Access Compliance Report Public Rights-of-Way (Curb Ramps)

Main Street: LANGFORD_RD Cross Street: RANUNCULUS_ST Location: W

ADA ID: RPRK211111114918 Ramp Type: Type 4 - Parallel Initial Pass/Fail: Fail Overall Compliance: No Severity Score: 30

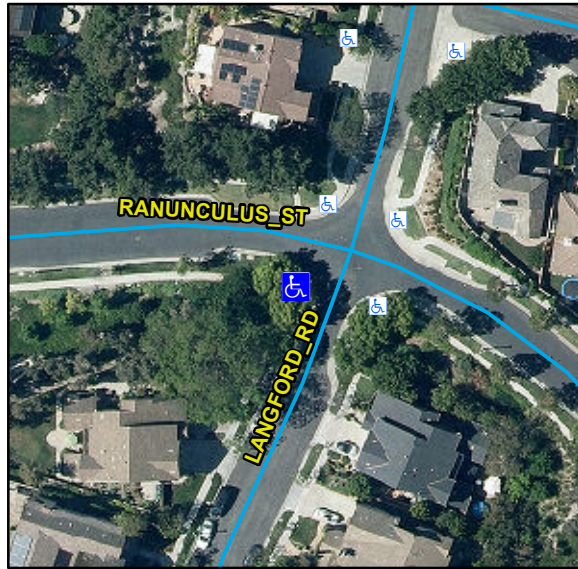
R204.3, R304.3.2, STD 1115

Compliance	Description	Data	Compliance	Description	Data
N/A	Ramp Length LT (in)	128	N/A	Ramp Length RT (in)	146
Yes	Ramp Width LT (in)	54	Yes	Ramp Width RT (in)	54
No	Ramp Run Slope LT (%)	16.5	No	Ramp Run Slope RT (%)	8.6
Yes	Ramp Cross Slope LT (%)	1.3	Yes	Ramp Cross Slope RT (%)	1.1
N/A	Landing Present	N/A	N/A	DWS Provided	N/A
N/A	Landing Length (in)	N/A	N/A	DWS Contrast	N/A
N/A	Landing Width (in)	N/A	N/A	DWS Length (in)	N/A
N/A	Landing Run Slope (%)	N/A	N/A	DWS Full Width	N/A
N/A	Landing Cross Slope (%)	N/A		DWS Offset Type	N/A
N/A	Landing Movement Obstructed?	N/A	N/A	DWS Offset Left (in)	N/A
	Landing Movement Type	N/A	N/A	DWS Offset Right (in)	N/A
N/A	Landing Shared	N/A			
N/A	Clear Space	Yes			
N/A	Clear Space To Crosswalk (in)	N/A			
N/A	Marked Crosswalk 1	No	N/A	Marked Crosswalk 2	No
	Crossing 1 Direction	SE		Crossing 2 Direction	NE
	Marked Crosswalk 1 Width (in)	N/A		Marked Crosswalk 2 Width (in)	N/A

Remove & Replace Curb Ramp With Two New Directional Ramps or Equivalent.
